Mr. BLATNIK. Time is running out on us. Mr. Linko, would you proceed with your presentation?

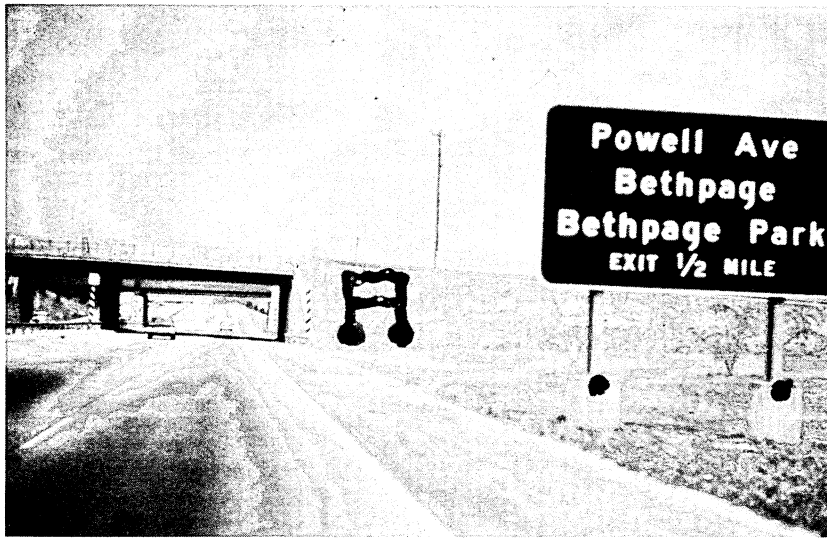
Here you see two concrete stanchions that must be 21½ feet in diameter and about 2 or 3 feet high, capable of wiping out any car. There is no good reason for the sign to be at this location. They put in a second hazard close to where one already exists—the roadsides are saturated with this type.

As you see, it says "one-half mile." A little further you see a natural hazard, a bridge abutment and embankment. I feel the better place to put this would be at the bridge. I cannot understand why they put it in here. If anyone hits that, he is finished.
